**CASE: 2020-01 30 Prospect Avenue – Russell Forsberg**

**REQUEST:** Conversion of an existing single-family residential structure to a two-family structure by constructing a two-bedroom residential unit in the basement. There will be no changes to the exterior of the structure.

Re: DPW Review Comments  
Special Permit Application  
Case #2020-01

Google Maps photos dated August 2018,

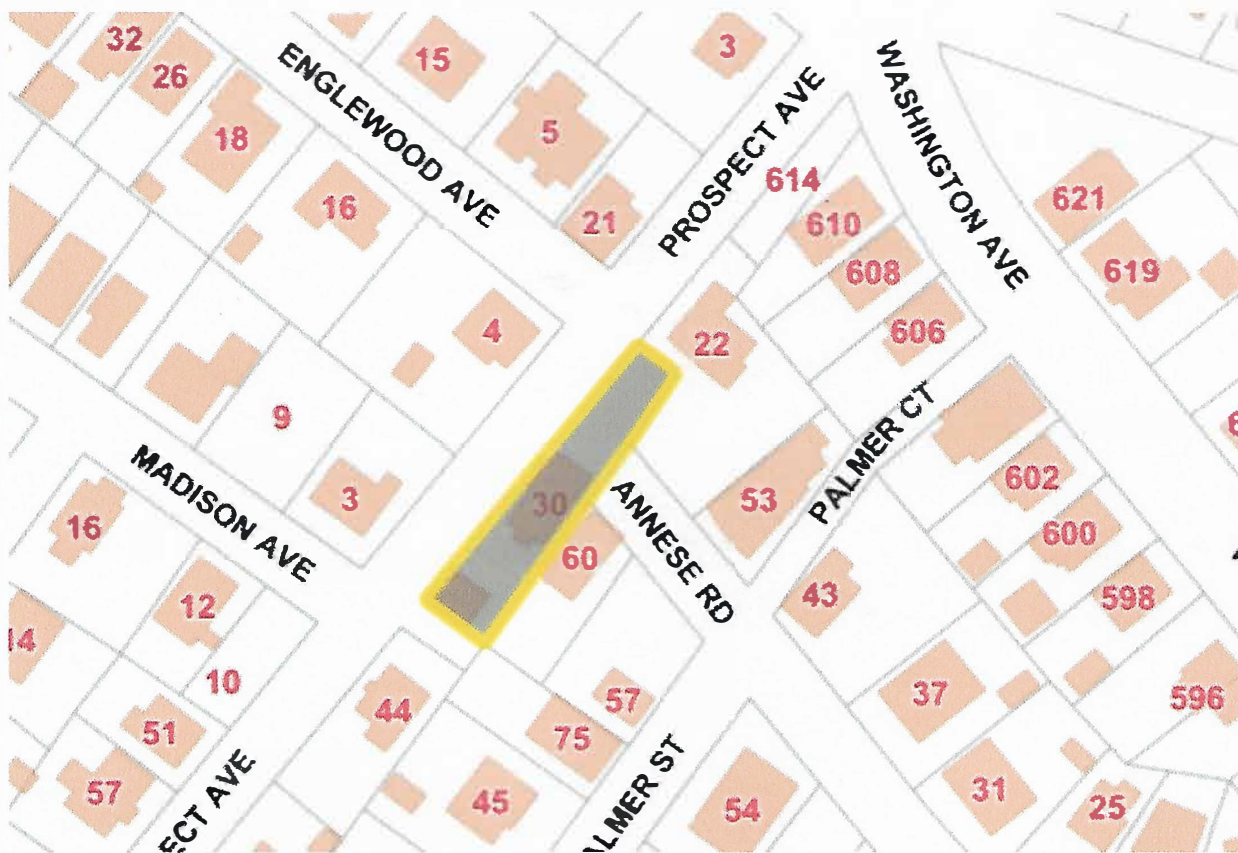
- it appears that the existing paved parking area is to be enlarged to fit two off-street parking spaces. This will require a wider curbcut, which could affect the amount of on-street parking allowed on that side of the street, although not by much.
- Snow removal and storage? Garbage storage?
